From: Davidson, Joanne (East Area Development Manager)
Sent: 25 February 2021 12:26
To: Litherland, Ceri M (ESNR-Planning)
Subject: RE: 20/0748 - Uskmouth Power Station Conversion - Potential Call-in

From: Litherland, Ceri M (ESNR-Planning)
Sent: 25 February 2021 12:00
To: Davidson, Joanne (East Area Development Manager)
Subject: 20/0748 - Uskmouth Power Station Conversion - Potential Call-in

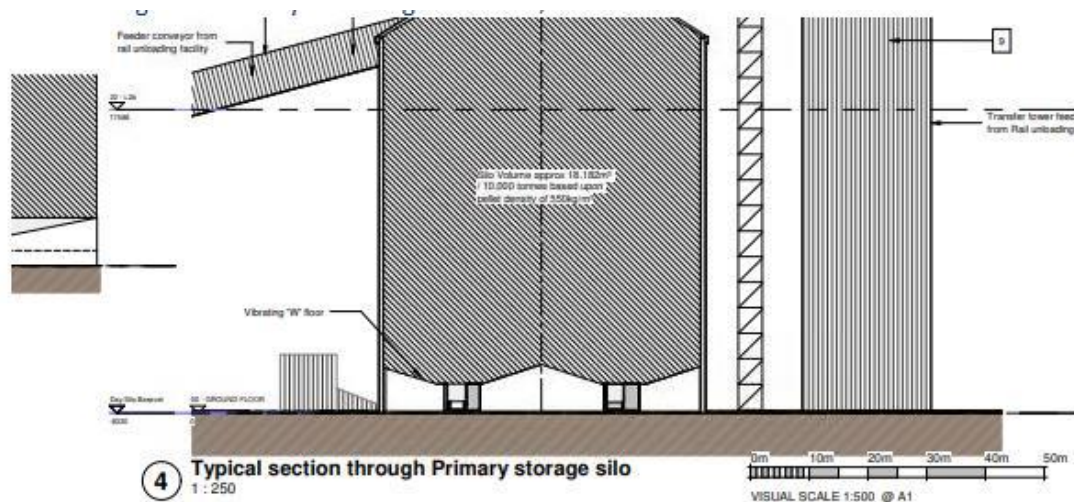
NRW most recent letter suggests a condition - *Condition 7: Secure implementation of approved plans demonstrating the primary storage silos are above predicted flood levels.* With regard to that condition, can you confirm that the developer submitted revised plans showing the elevation of the storage areas out of the flood plain?

The plans already showed this:

There is 3m between the ground level and the “vibrating floor” of the silo.
